MEMORANDUM

SUBJECT: SP 05-21 PINEBROOK

DATE: JUNE 10, 2008

**PLANNING COMMISSION MINUTES
PRELIMINARY SITE PLAN APPROVAL
MARCH 22, 2006**

SITE PLAN
PINEBROOK PROFESSIONAL CENTER
 PART OF THE SOUTHEAST 1/4 SECTION 24
 T. 1 N., R. 8 E., CITY OF NON
 OAKLAND COUNTY, MICHIGAN

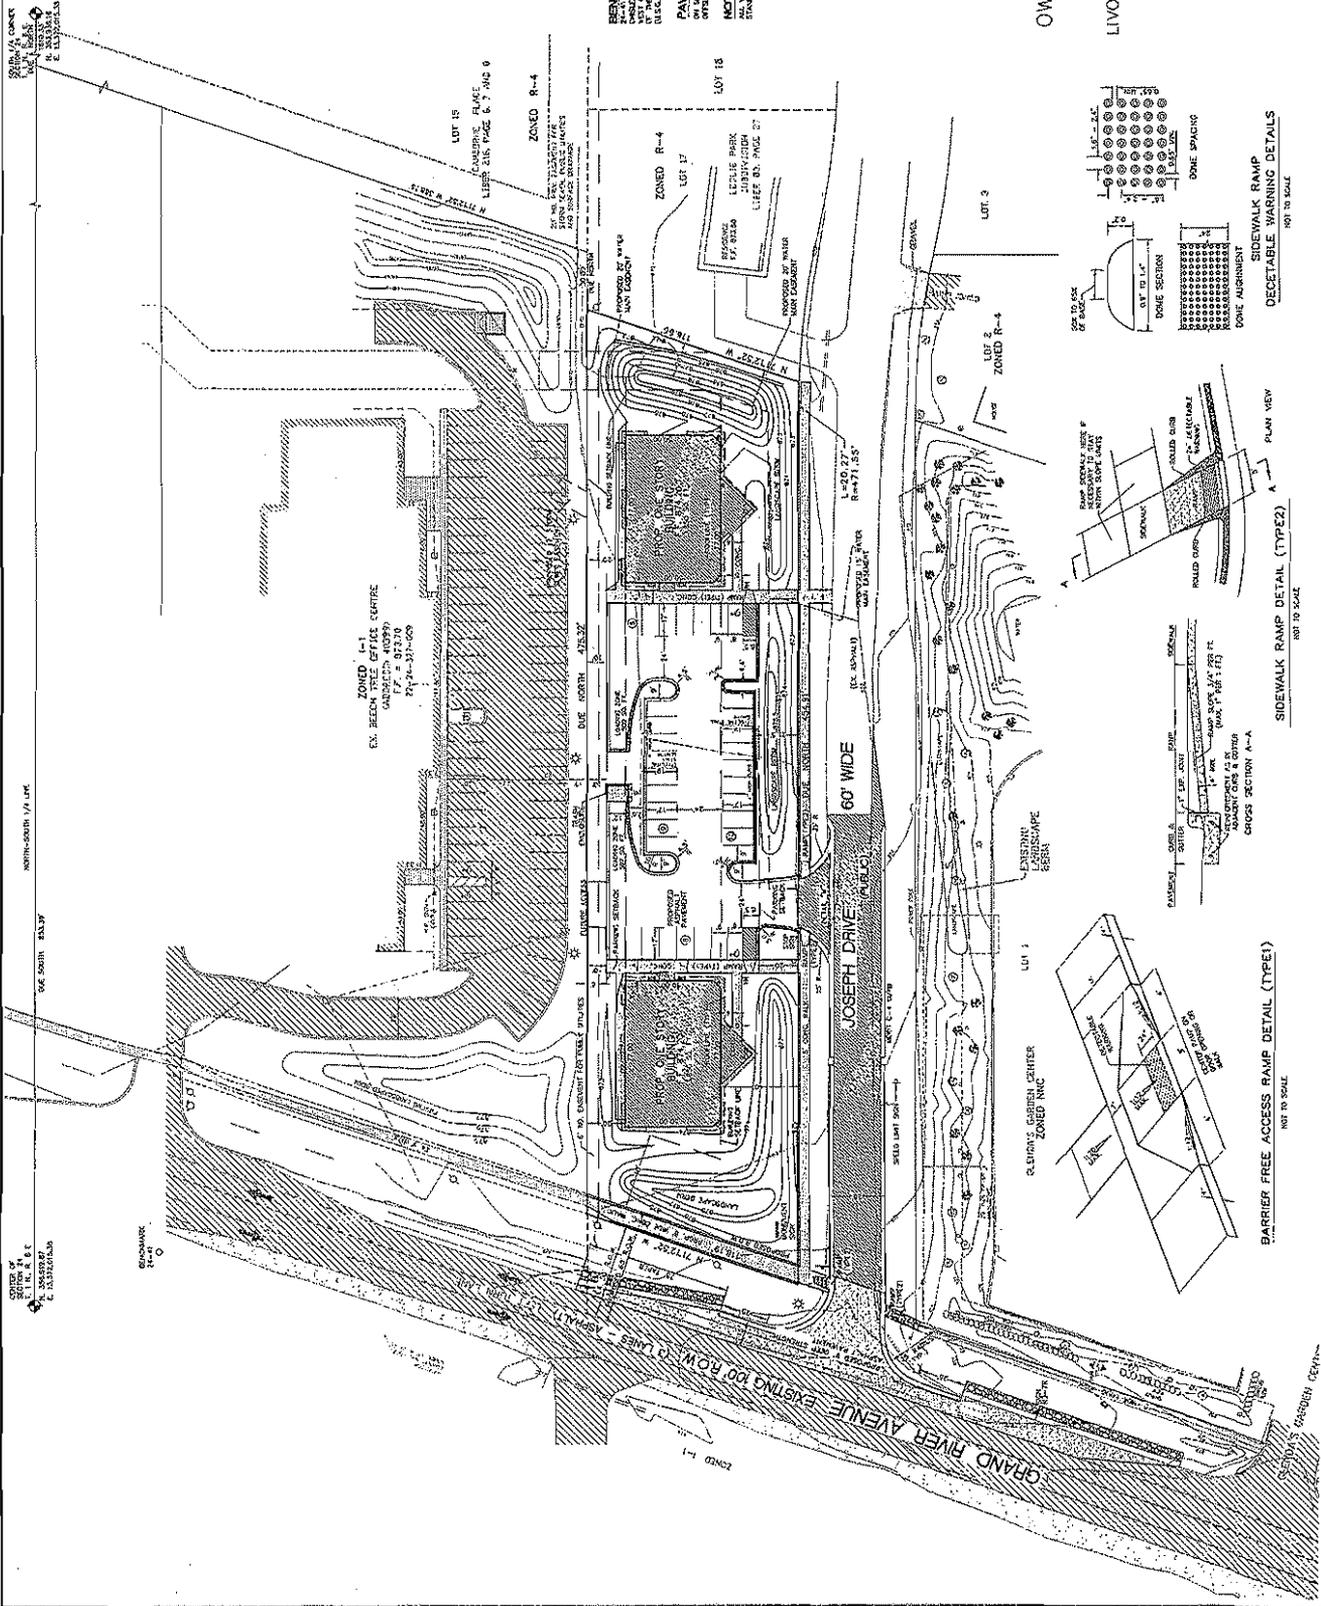
The Site Plan demonstrates general compliance with the standards of the Zoning Ordinance except for a few items. The parcel does not meet the minimum lot area requirement of two acres for the NCC District. A Zoning Board of Appeals variance is required to build on a non-conforming lot. The Applicant has indicated a desire to pursue this variance. Staff supports this variance since this site is an existing non-conforming lot platted for residential purposes many years ago, and the surrounding properties are currently developed with existing uses.

The plan meets the minimum requirements for parking. 35 spaces are required, and 35 are provided. This district permits the use of medical, retail and restaurant uses. The amount of parking required for those uses would not be met by this plan.

770 square feet of loading and unloading area are required per building. Two loading areas with a total area of 1,007 square feet are proposed which results in a shortage of 533 square feet. A Zoning Board of Appeals variance is required to reduce the area below the area required in the Ordinance. Staff supports this variance since the two loading and unloading areas are less than thirty feet from each other and could be used for deliveries to either building. Also, if the buildings fronted Grand River Avenue instead of Joseph Drive only 500 square feet of loading area would be required per building.

The Landscape Architect does not recommend approval of the plan. The adjacent to residential berm requirement for a six-to-eight foot high berm with a five foot wide flat crest was not provided. The measurement is made ~~between~~ from the finished floor elevation of the adjacent home to the top of the berm. The contours provided indicate grading around the home at 872 and the top of the berm is 879. The finish floor elevation for the home is not provided, and must be provided, along with the adjusted height of the berm. The flat crest of the berm is three feet wide instead of five feet. A profile of the berm was not provided. The sub-canopy trees are within 15 feet of overhead wires and need to be relocated. Also, trees cannot be planted within twenty feet of utility poles. The Applicant has agreed to make these changes.

The Engineering Review recommends approval subject to the Applicant receiving a Design and Construction Standards Variance from the City Council to eliminate the curb requirement along Joseph Drive. Other minor issues can be corrected on the Final Site Plan.

The Fire Marshal has not recommended approval of this site plan due to access issues. Several design alternatives are available to satisfy his issues. The Applicant has decided to seek a City Council general appeal Variance from the Fire Marshal's requirements for an access road length without adequate room to turn-around the largest fire truck and all points around the perimeter of the building to be no more than 175 feet of hose laying distance from proposed hydrant. The Applicant has agreed to meet the minimum outside turning radius of fifty feet, another requirement of the Fire Marshal.

Member Kocan asked about the berm. She looked at the berm and saw the 872 and 879 numbers. She was thinking about the seven-foot berm. She did recall going over the berm Ordinance very carefully to make sure that properties that are either lower or higher, that the actual impact of the berm is real as opposed as perceived. The Planning Commission needs to know what the finished floor elevation of the house is. Once that is determined, then the Member Kocan would be looking for the six-to-eight foot berm with the five-foot crest. If she was asking for that, she wondered if there was enough room between the property line and the building to put that size of a berm in place.

Member Kocan said she finds that the "dots" on the plan and the actual plantings are as different as night and day. Where the plan indicates that there is no room between trees, the actual plantings provide fifteen-foot spaces. The difference is significant. She said there were numerous places throughout the City where examples of this could be found. Plans look good on paper, but it takes ten or fifteen years for the landscape to look really good. She said this issue is going to come before the Implementation Committee because it is a real concern. Member Kocan confirmed that the Leslie Park Subdivision has nothing to do with the area that is affected by this design. Mr. Soave also stated that the screening on the east side of the property is adjacent to Beech Tree's loading zone and exit doors. He said that their delivery trucks will indeed be the smaller trucks. He said he tried to have a curb cut off of Grand River, which is prohibited due to the fact that so many are already there.

Member Avdoulos said he was also concerned about the circulation within the site. There is a tight spot near the barrier-free area in the south. He understood the constraints of the site. He just felt that the design was a bit too uncomfortable. From the Fire Department's point of view, plans could be acceptable if the trucks could pull up alongside the property when on-site maneuverability was amiss. He thought that the north building has better access. The south building requires navigational skills. But, the trucks could pull up on Joseph. Also, the neighboring site has a drive that could provide access to the building. He wasn't that worried about those concerns.

Member Avdoulos saw that the plan has a "future access" notation and wondered if that note would remain. Mr. Soave said that he planned to leave the notation, which was located just north of the south building. Mr. Donnan

In the matter of Pinebrook Professional Building, SP05-21B, motion to approve the Preliminary Site Plan subject to: 1) A ZBA variance for minimum lot area; 2) A ZBA variance to encroach 13 feet into the required 40-foot front yard setback; 3) A ZBA variance to reduce the required loading/unloading area by 533 square feet; 4) A Planning Commission Waiver of the following landscape requirements, or the Applicant correcting these issues on the Final Site Plan submittal: The adjacent to residential berm requirement, the sub-canopy trees within fifteen feet of the overhead wires, and the planting of trees within twenty feet of the utility poles; 5) A Planning Commission Section 9 Waiver to permit facades with up to 61.56% asphalt shingles; 6) A City Council Variance for the paving of a portion of Joseph Dr. without curb and gutter; 7) A City Council General Appeal Variance of the minimum outside turning radius of fifty feet requirement, or plans being modified at the time of Final Site Plan submittal; 8) An additional fire hydrant being added to the plan, once the issues have been worked out *with* the Fire Marshal; 9) A City Council General Appeal Variance for an access road length without adequate room to turn around the largest fire truck, or plans to being modified at the time of Final Site Plan submittal; 10) A City Council General Appeal Variance of the Fire Marshal's request that the building be no more than 175 feet of hose-laying distance from the proposed hydrant, with the hope that the plans will be modified with another hydrant at the time of Final Site Plan submittal; and 11) All the comments on the attached review letters being addressed on the Final Site Plan; for the reason the plan otherwise meets the Master Plan for Land Use.
